Subject: Recall Campaign SR12-26
Power Cable Rubbing Protection
Some X3-45 coaches, XLII Entertainer Bus Shells and X3-45 VIP Bus Shells
Model Years 2011 up to 2013
Defect Report – revised July 20th 2012

Defect Report

Recall Campaign Number Prevost SR12-26
Subject: Power Cable Rubbing Protection

Location of the Rear electrical compartment's panel lower edge (see arrows) at risk of rubbing against power cables

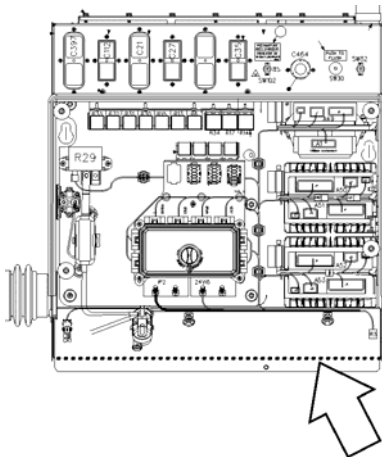
- **Description:** The vehicles involved in this recall need to have their rear electrical compartment's power cables inspected.
- **Cause of the defective condition:** Power Cables might be rubbing against the rear electrical compartment's panel lower edge (part number 068124).
- **Consequence:** possibility of short-circuit, or fire due to wear of power cables.
- **Warning that can precede:** May be noticed at routine inspection.

Recalled vehicles might have their power cables rubbing against the rear electrical compartment's panel lower edge. The remedy will route cables away from this sharp edge, if needed.
